NOVEMBER 17, 2025

CONTRACT No. 1827

MISC. HVAC IMPROVEMENTS PROJECT

ADDENDUM No. 02

510-ET-01
ELECTRICAL POWER FIRST FLOOR NEW
WORK PLAN

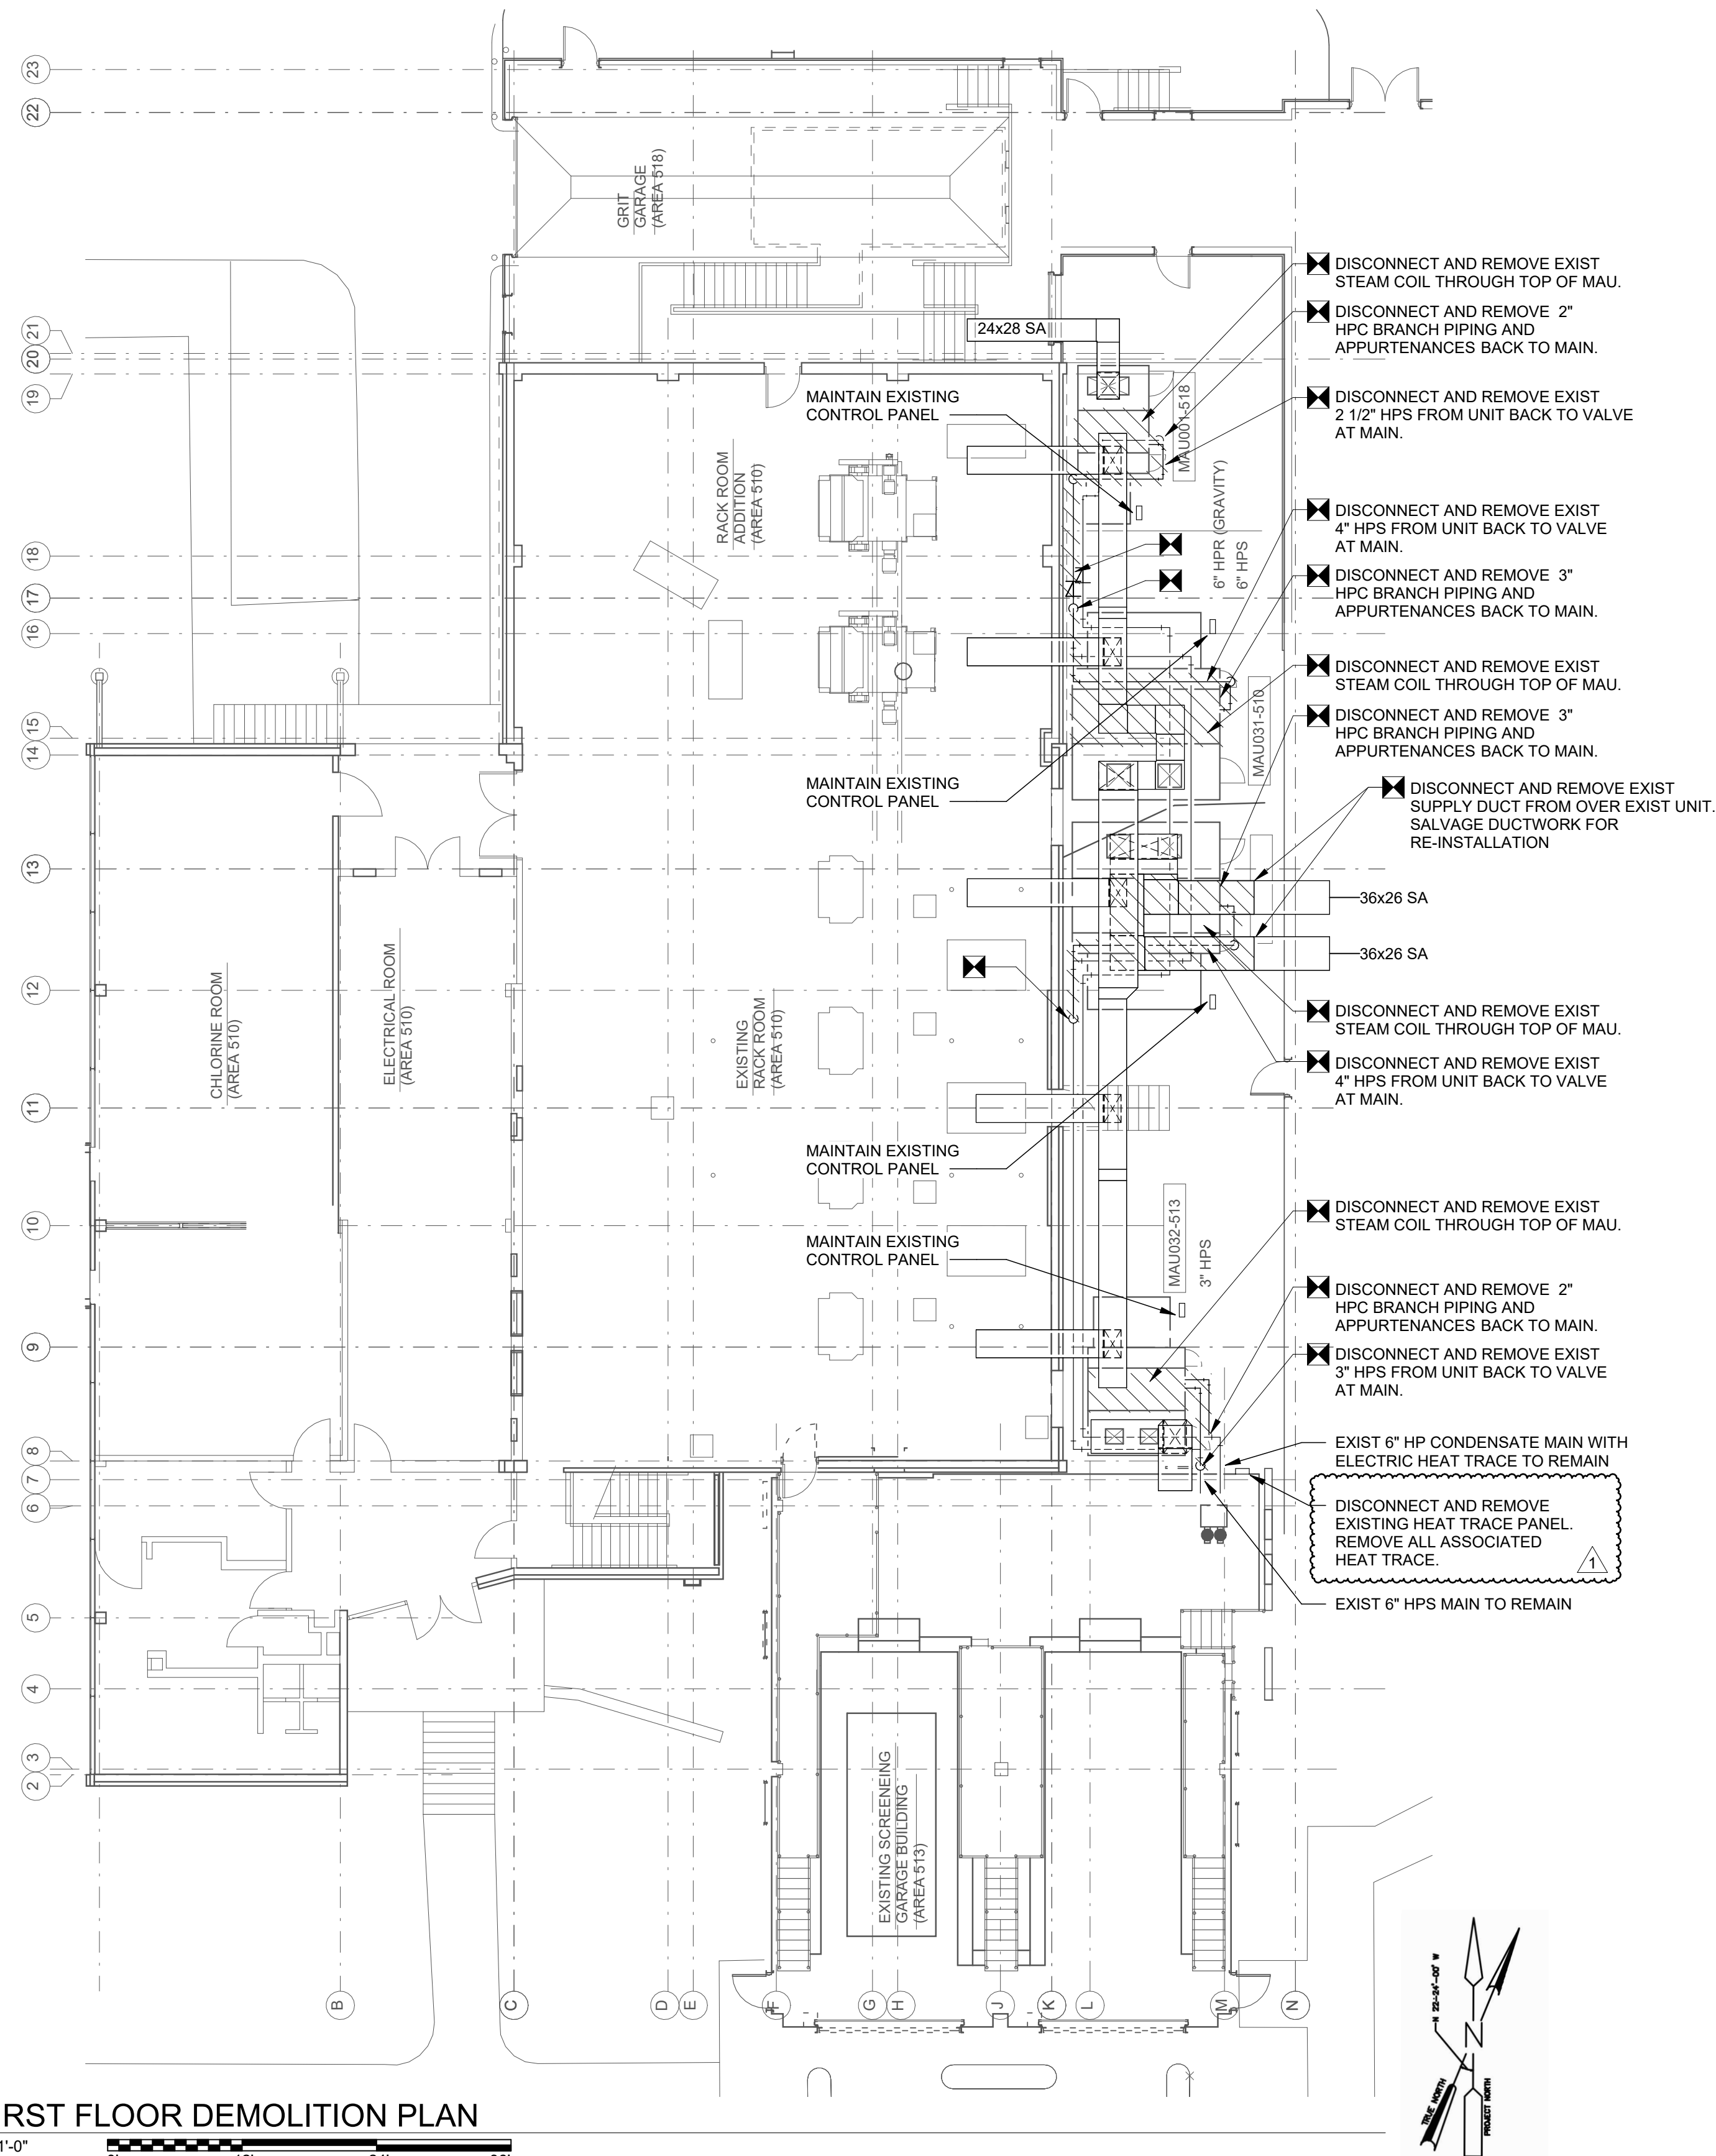
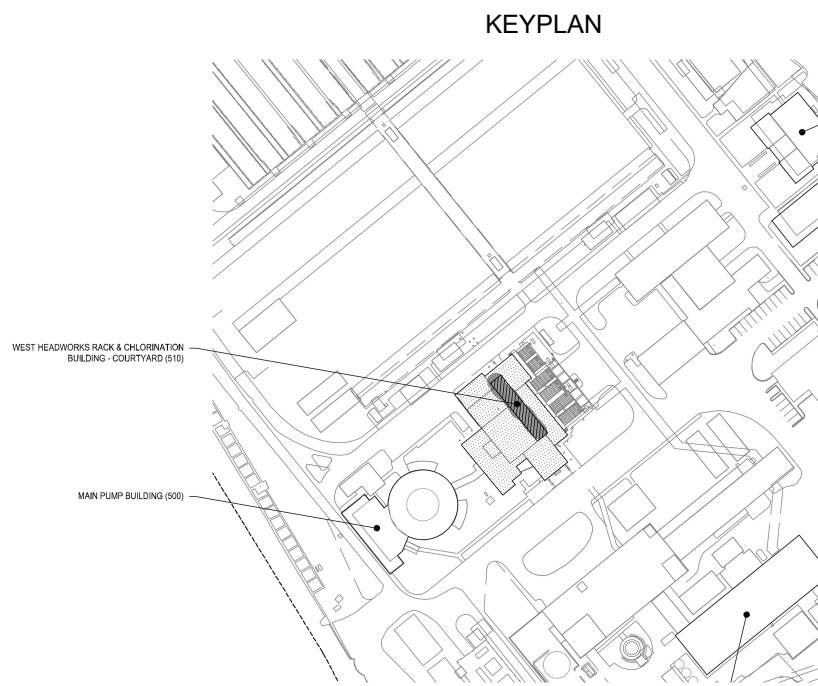
- 2.1 510-EDT-01-ELECTRICAL POWER FIRST FLOOR DEMOLITION PLAN
- 2.2 510-ET-01-ELECTRICAL POWER FIRST FLOOR NEW WORK PLAN
- 2.3 510-HDM-01-HVAC FIRST FLOOR DEMOLITION PLAN
- 2.4 510-HM-01-HVAC FIRST FLOOR NEW WORK PLAN

510-HDM-01
HVAC FIRST FLOOR DEMOLITION PLAN

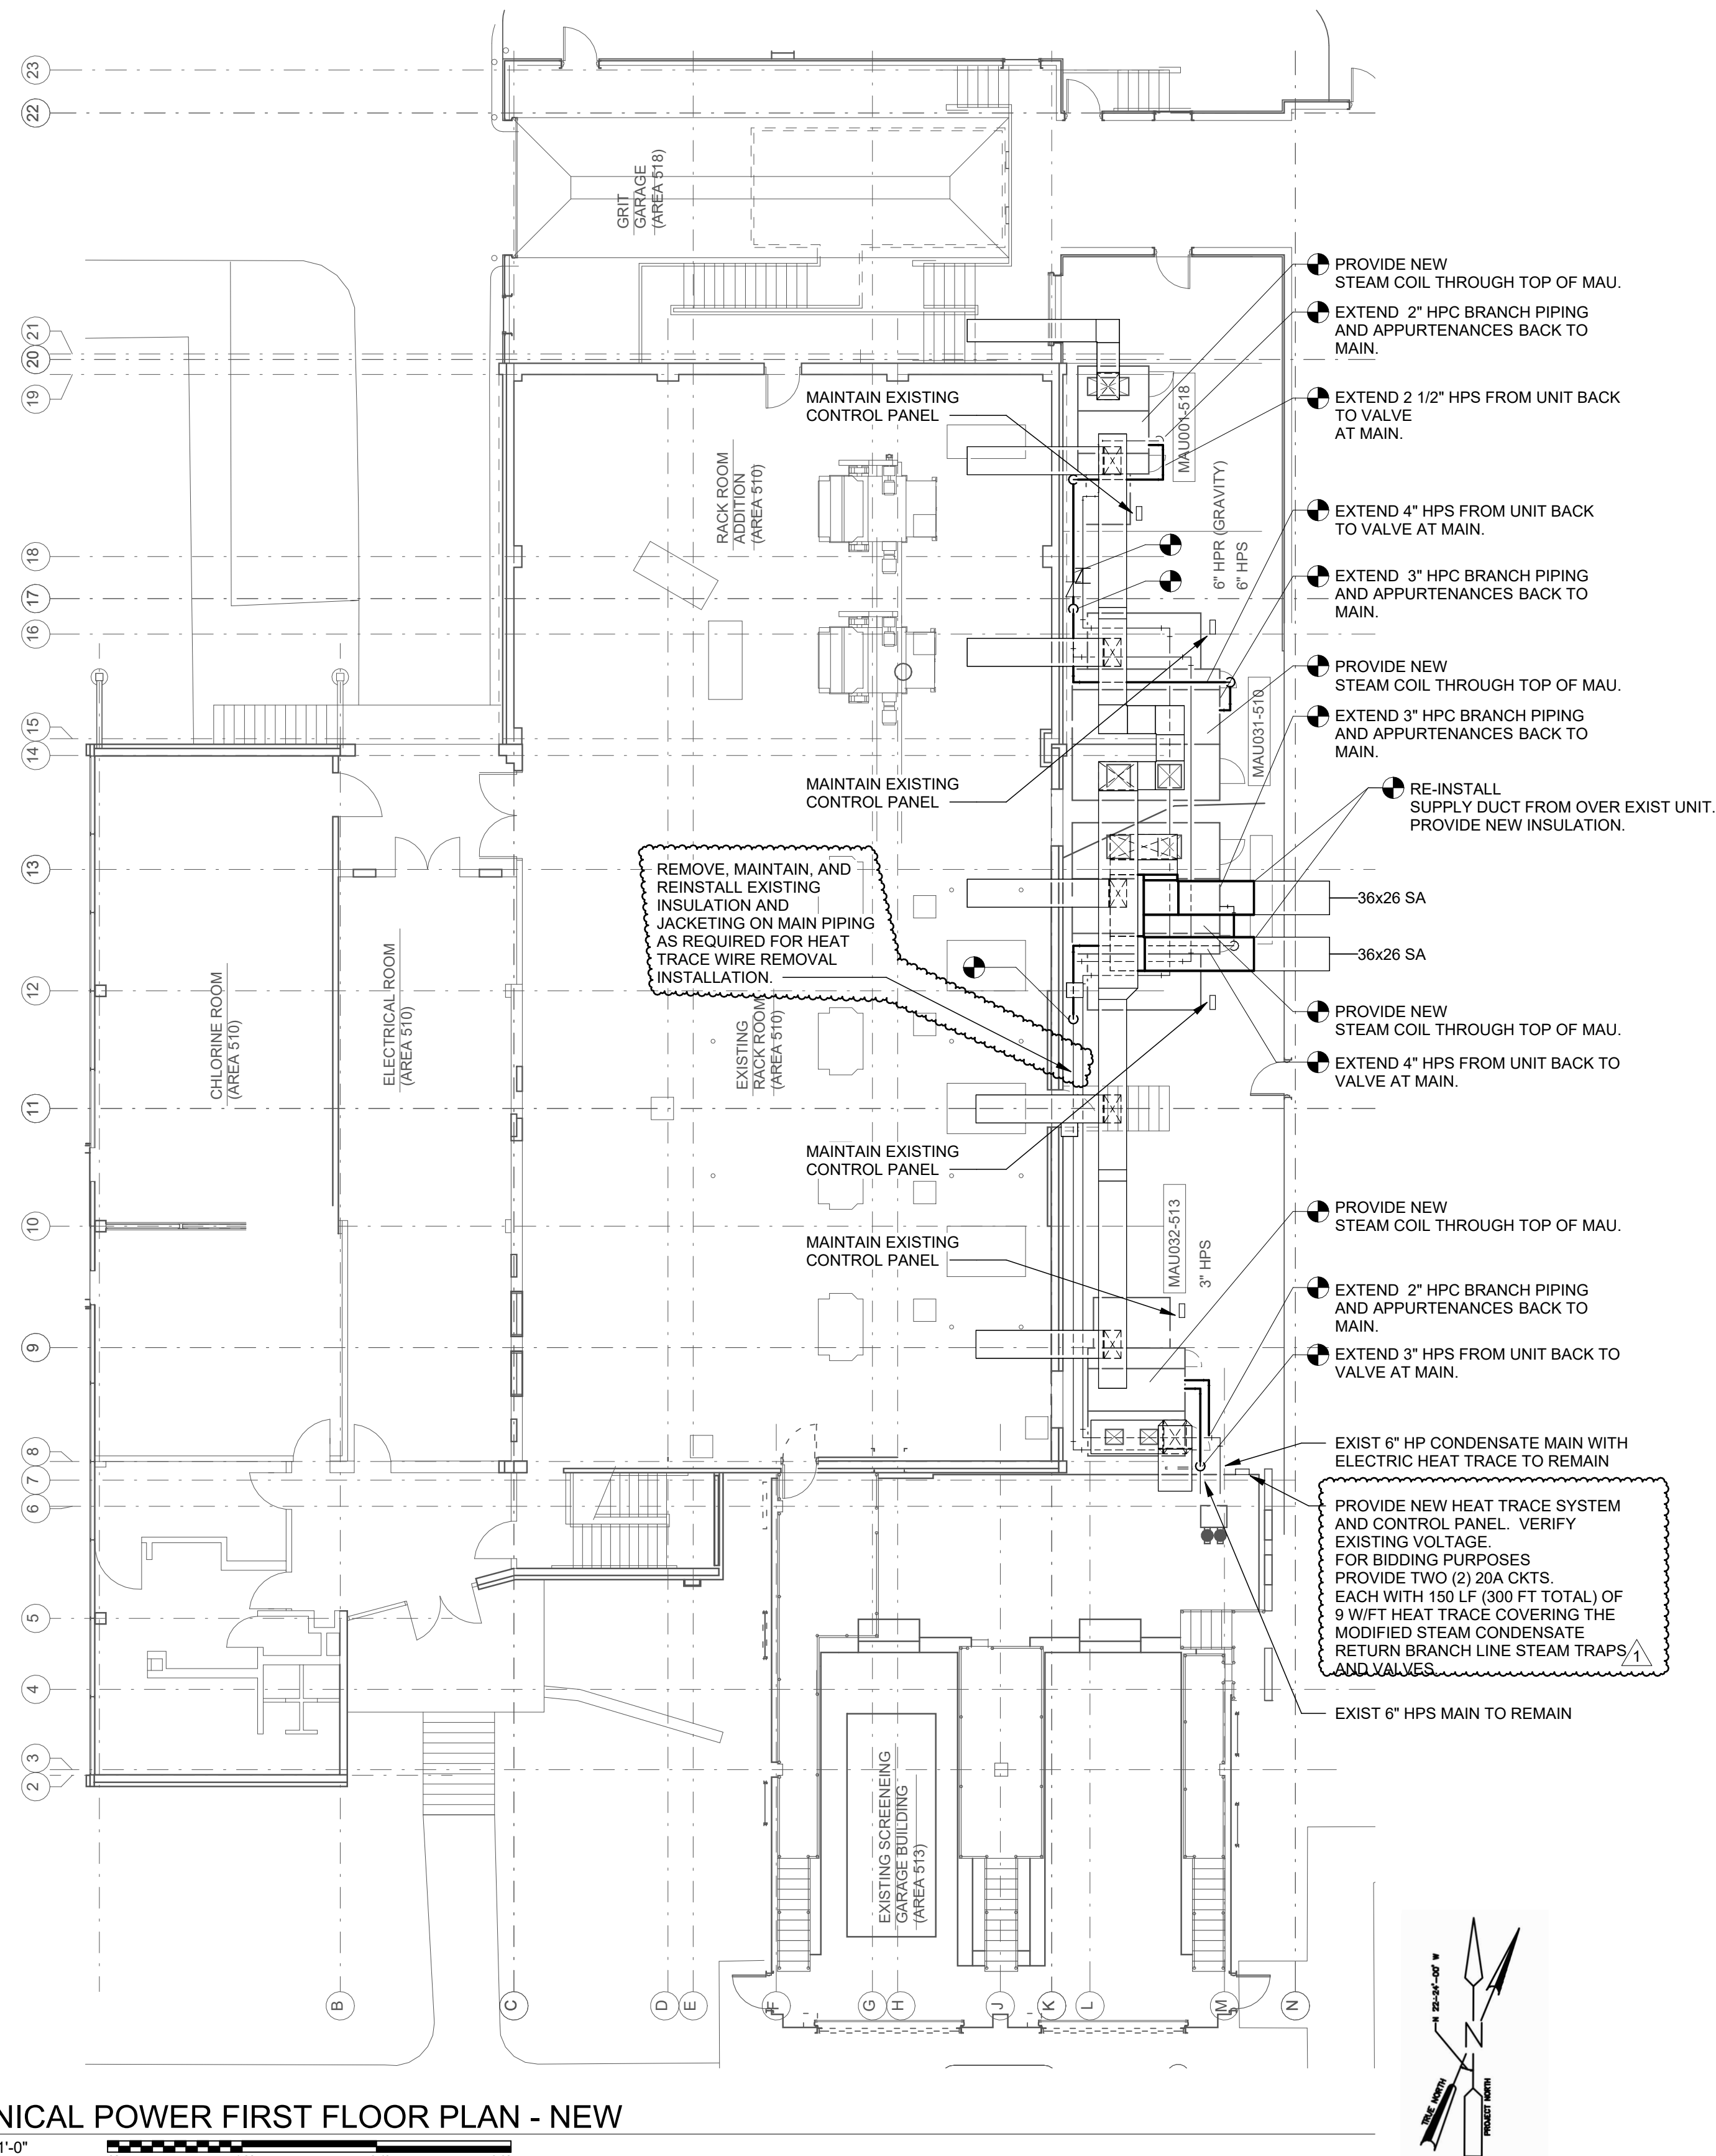
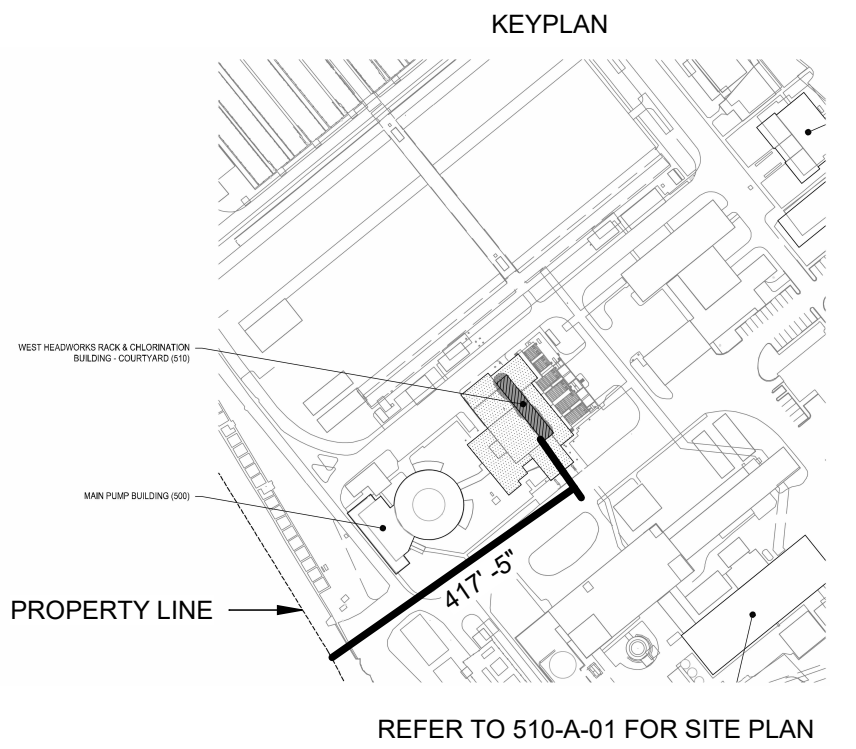
Q3: Drawing 510-HDM-01. This is asking us to inspect and reinstall existing if in proper working order. Can you clarify the heat trace amount we are to bid on within this area, or are we only to bid new back to tie in point?

NOTE:
REMOVE PIPING INSULATION AND HEAT TRACE BACK TO TIE IN POINT. INSPECT HEAT TRACE FOR FUNCTIONALITY. REINSTALL EXISTING HEAT TRACE IF IN PROPER WORKING ORDER. ALERT OWNER IF HEAT TRACE IS BEYOND USEFUL LIFE.

A3: See Addendum 02 drawing sheets and specification summary of work for more information. Heat trace to be fully removed and replaced. Insulation and Jacketing to be salvaged and reinstalled.
